Appl. No. 10/708,104  
Amdt. dated June 06, 2005  
Reply to Office action of March 09, 2005

**Amendments to the Drawings:**

**REMARKS/ARGUMENTS**

Fig. 6

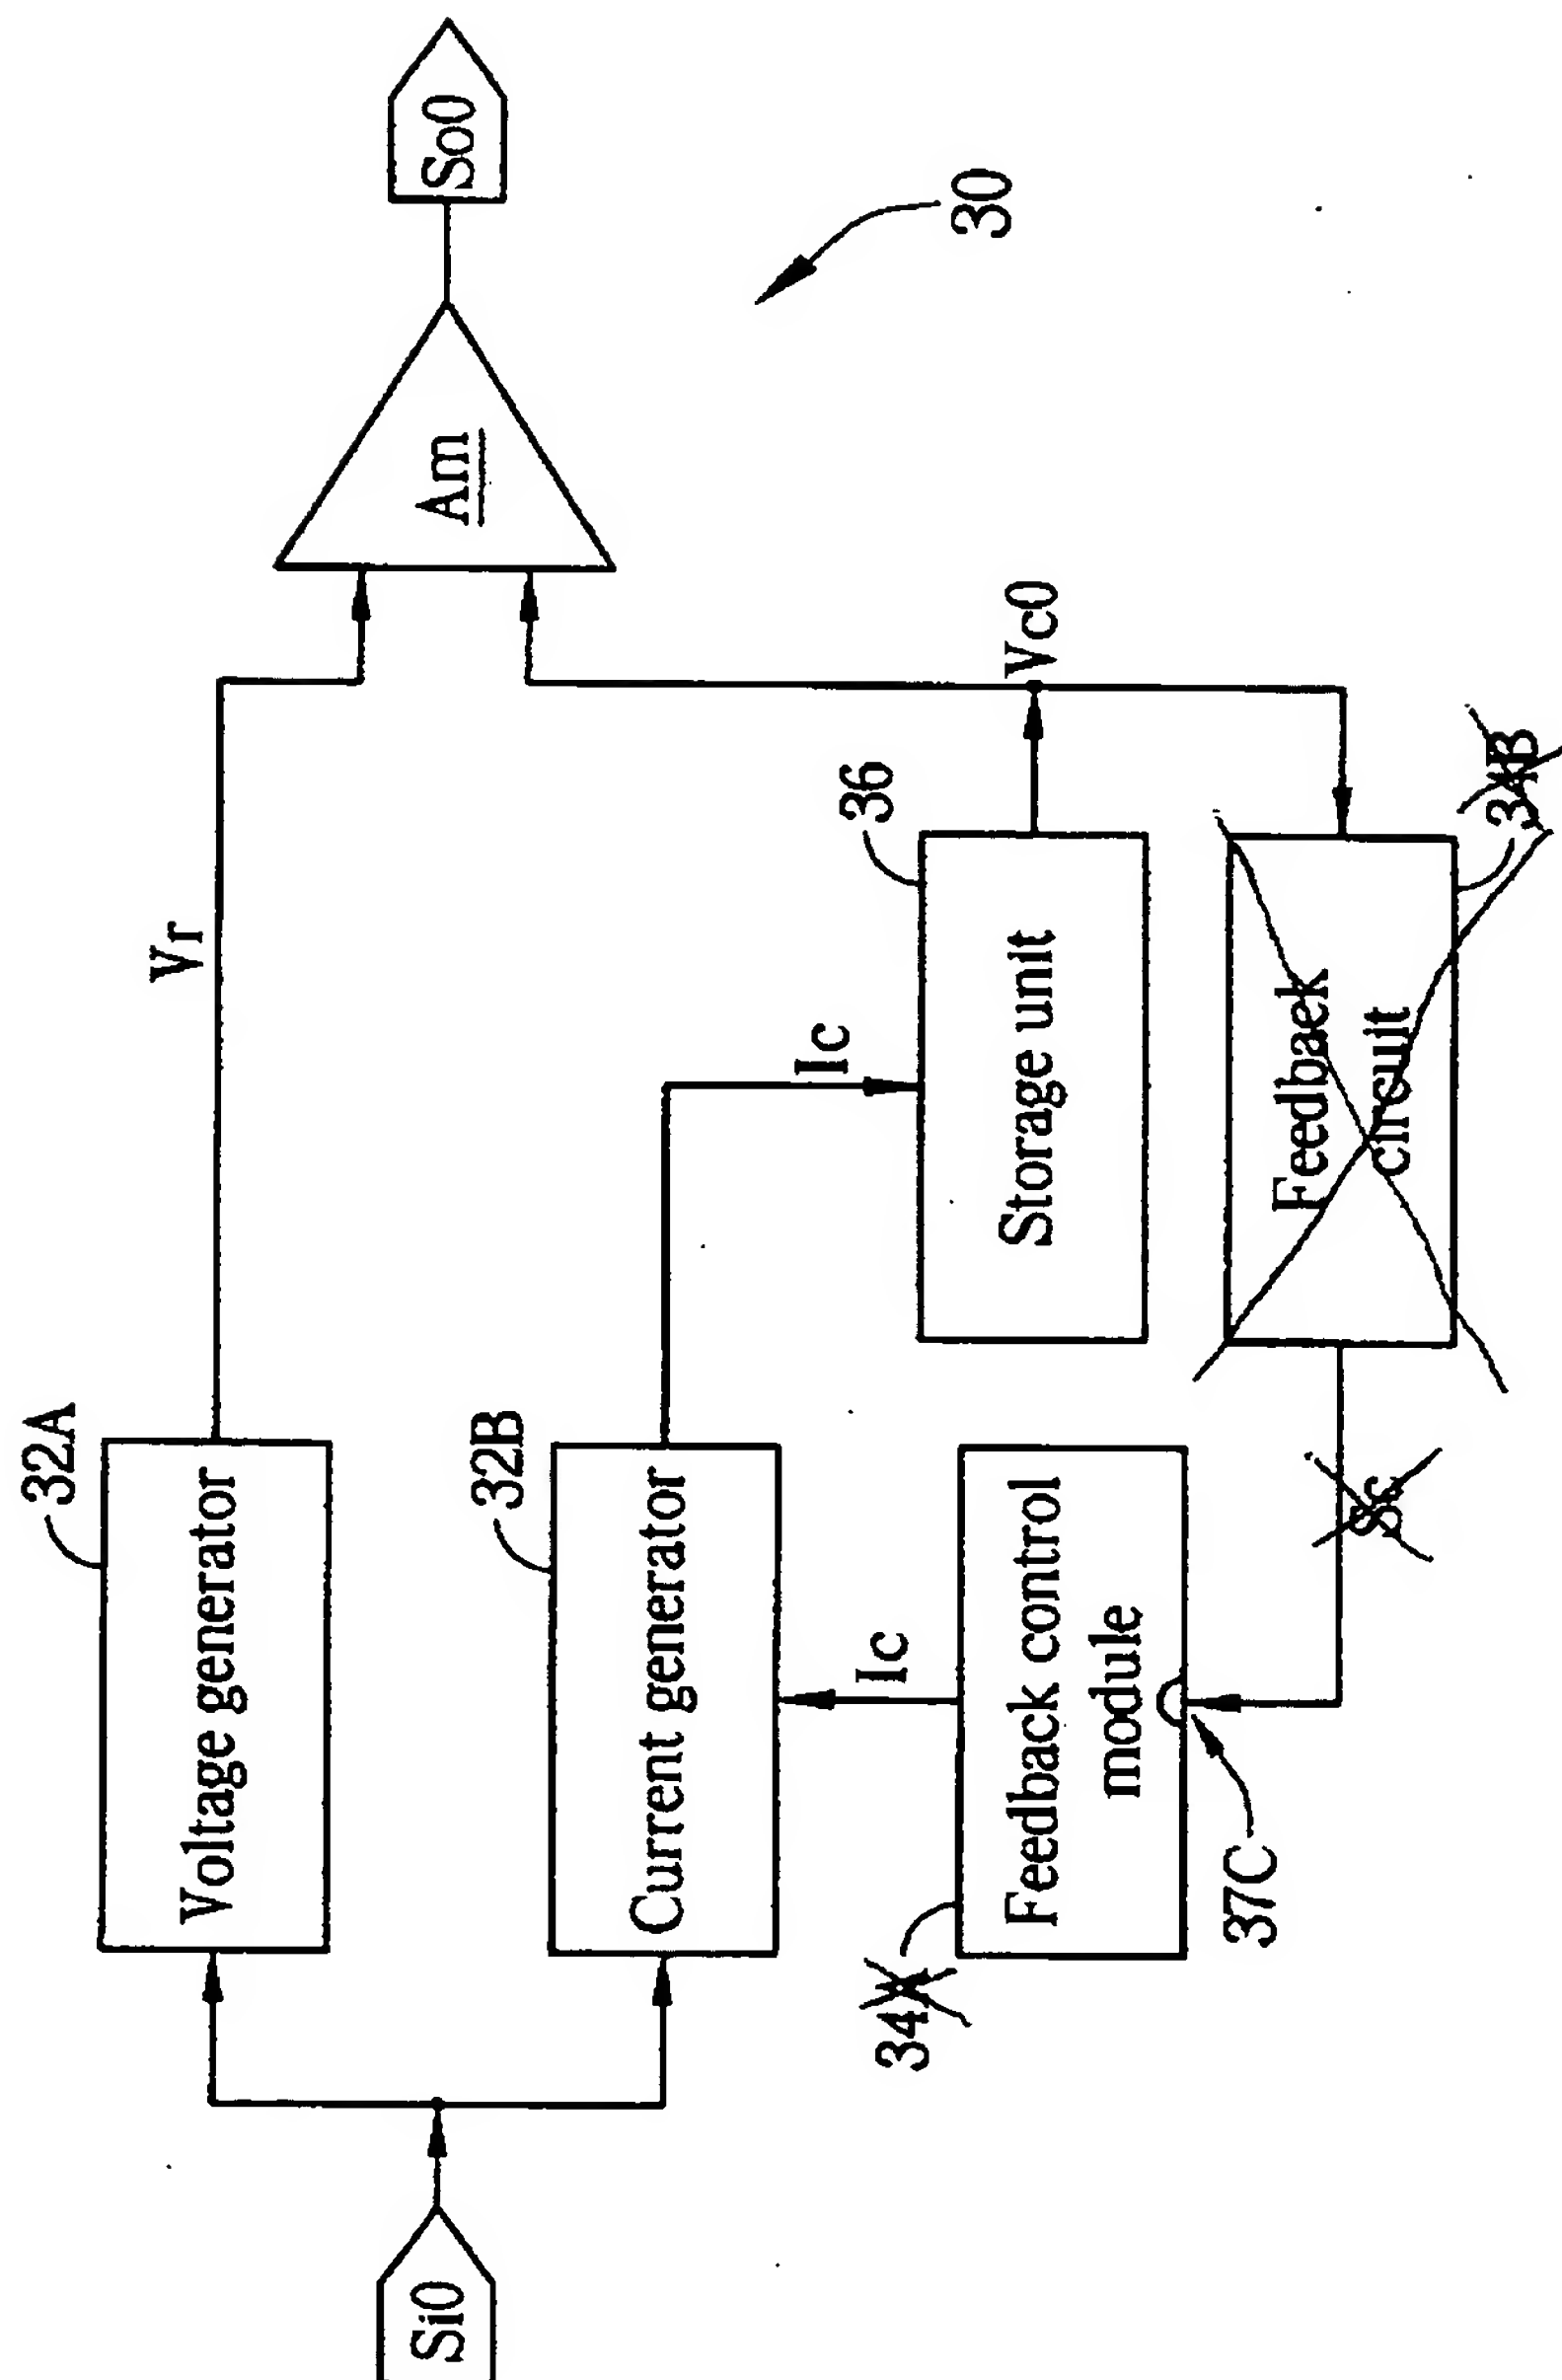
The attached sheet of drawings includes changes to Fig.6. In Fig.6, the feedback circuit 34B has been removed, the control signal Sc has been removed, and the reference number for the feedback control module has been changed from 34A to 34. In place of the feedback circuit  
5 34B, a connecting wire has been drawn in Fig.6. This change to Fig.6 is supported in Fig.7 of the instant application. The specification has also been amended according to the changes made to Fig.6. Acceptance of the amended drawings is respectfully requested.

The feedback circuit, now removed, was intended to be a wire connecting the output of the storage unit 36 to the control end 37C of the feedback control module 34. Due to the confusion that the term "feedback circuit" caused, all reference to the feedback circuit and the control signal Sc has been removed from the claims, the specification, and the drawings. The claims and the specification now state that the feedback control module 34 adjusts the charging current Ic according to the charging voltage Vc0 instead of according to the control signal Sc. No new matter has been added through these changes, and all changes are supported in the specification and the figures such as Fig.7. Claims 1 and 2 were both amended to remove recitation of the feedback circuit.
